HOLLAND Fifth Wheel Service Bulletin, FW17 Series Fifth Wheel Top Plates Release Handle Gap. (XL-FW20161SB)

2018 & 2019 model Freightliner Cascadia's and Western Star 5700s built between 02/14/2018 and 10/23/2018 and built with a Holland FW17 series fifth wheel.

Release Handle Gap FW17 Series Fifth Wheel Top Plates

January 2019

Figure 1

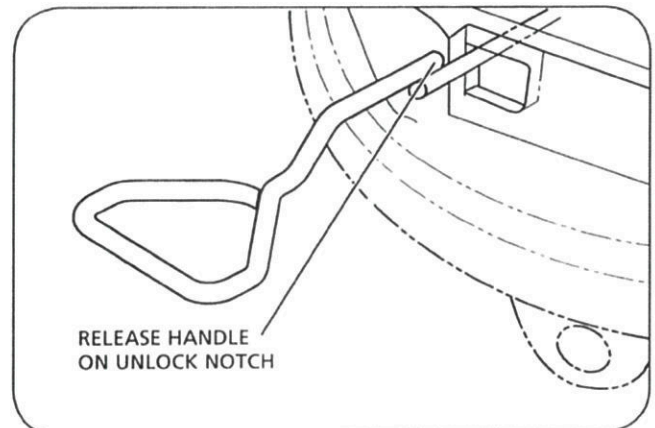
If your fifth wheel has this condition, when the trailer kingpin exits the top plate's locking mechanism, the fifth wheel's release handle remains on the top plate's unlocked notch (**Figure 1**) and does not automatically move to the "Ready-to-Couple" position (**Figure 2**). Therefore, the fifth wheel will remain unlocked during the next coupling attempt.

Figure 3

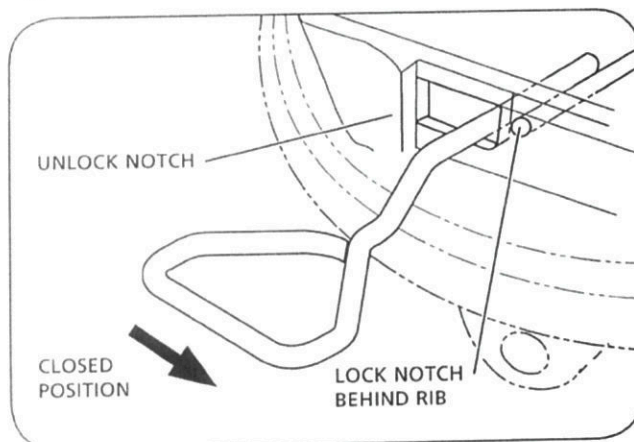
An operator can easily detect this issue when performing the required visual inspection of the tractor trailer coupling. The operator will notice that the release handle is not fully retracted in the closed/locked position with the lock notch behind the rib as shown (**Figure 3**) and the hook is not engaged behind the lock (**Figure 4**).

Figure 5

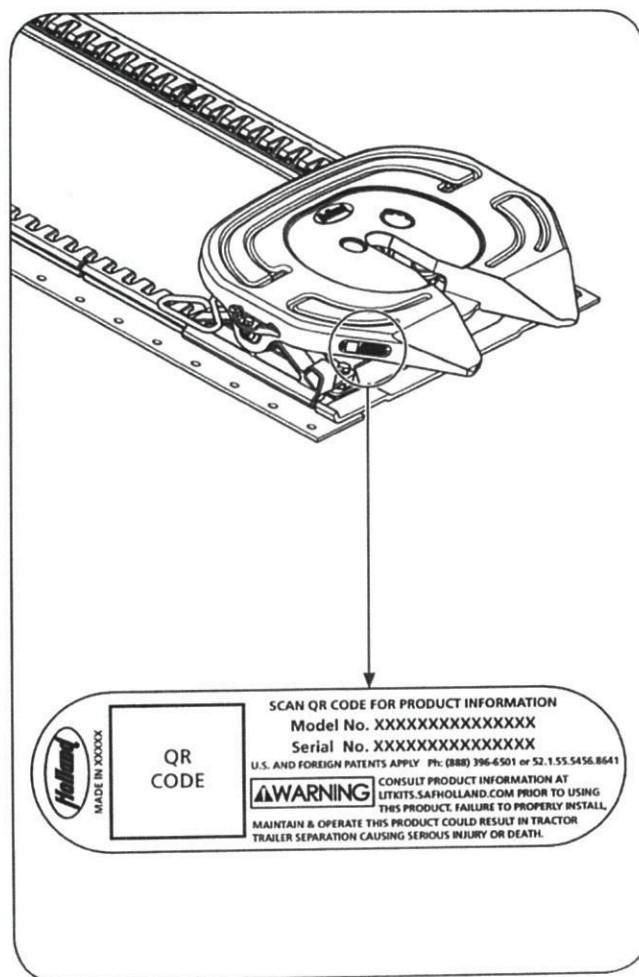
Fifth wheel serial tags are located on the left side of the fifth wheel top plate above the fifth wheel bracket pin or on the pickup ramps as shown (**Figure 5**). The part number and serial number are listed on the tag as shown (**Figure 5**).

Figure 6

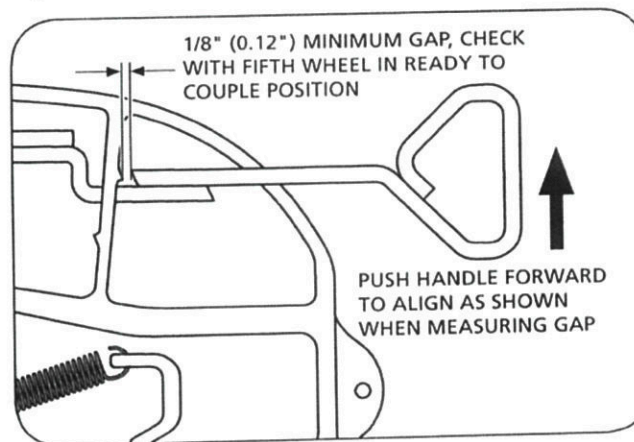
To inspect the gap, look under the fifth wheel on the driver's side of your truck when the fifth wheel is in the Ready-To-Couple position. This is achieved after the release handle is pulled out and engaged on the unlock notch of the casting, and a previously locked kingpin is fully removed from the locks. Pull the release handle towards the front of the fifth wheel to check the kick-off dimension by inserting a 1/8" (0.12") feeler gage between the release handle and the outside of the rib (**Figure 6**).

If the release handle remains in contact with the unhook notch or if gap is less than 1/8" (0.12"), the release handle needs to be replaced. Replace the release handle using Replacement Kit RK-171-11079-M. The standard SAF-HOLLAND warranty for the FW17 applies to these repairs.

Vehicles that have a gap equal to or greater than 1/8" (0.12") do not require repair and no further action is required.
